Re: Huntington Beach Energy Center Project (12-AFC-02)
Applicant's Responses to Staff's Data Requests, Set 1A (#1-72)

Huntington Beach Energy Project

Data Responses, Set 1A

(Response to Data Requests 1 to 72 and
Coastal Commission Letter CCC-1 through CCC-5)

FIGURE DR27-1a
Wetlands and Nature Preserves
AES Huntington Beach Energy Project
Huntington Beach, California

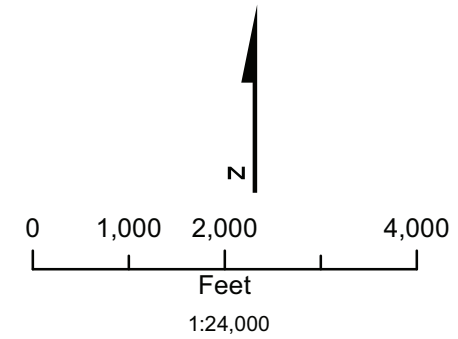
The delineation presented by the applicant does not provide a full assessment of the direct and indirect temporary or permanent impacts to the wetlands under the jurisdiction of the USACE and CCC. Section 5.2.3.2.5 of the AFC (page 5-2-35) determined that HBEP construction would not cause loss or fill of any wetlands. However, as depicted in Figure 5.2-2bR (Attachment DA5.2-5, AFC Supplement: Response to Data Adequacy Review), the proposed project has the potential to affect Estuarine and Marine Wetlands which are jurisdictional to the USACE and CCC.

| Application Number | Permit Number | Permit Issued Date | Permit Status | Equipment Type | Equipment Description | Application Date | Application Status |

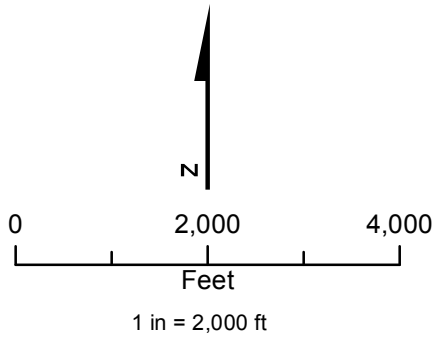
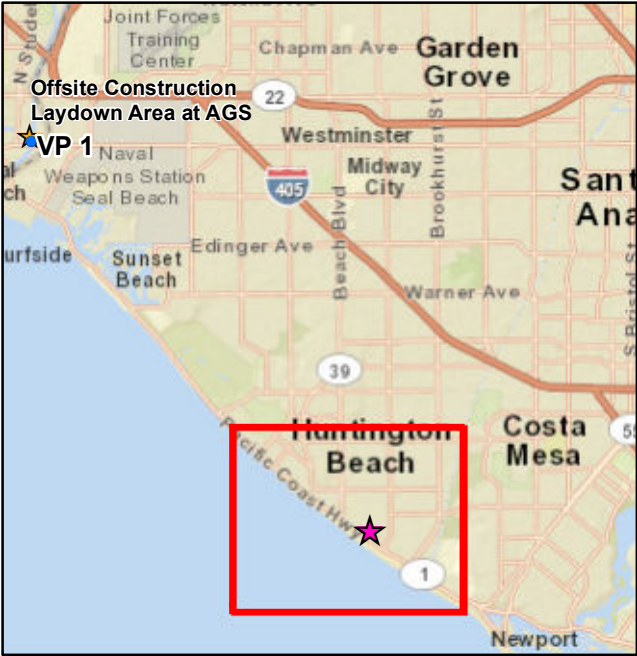
68. Please provide information on the meaning of the four viewpoints on Figures 5.13-1a and 5.13-1b. Please clarify whether and how those viewpoints correspond to the photographs of off-site construction laydown and parking areas.

Response: See the attached revised figures. Figures 5.13-1aR1 and 5.13-1bR1 indicate the correct locations of Viewpoints 1 through 5. Because Figure 5.13-1aR1 depicts the locations of each of the proposed offsite parking areas, the relationship between the viewpoints and these areas can be readily identified. The captions on Figures 5.13-2R1, 5.13-3R1, and 5.13-4R1 now include a reference to the viewpoint number used to identify the location of the viewpoint on Figures 5.13-1aR1 and 5.13-1bR1.
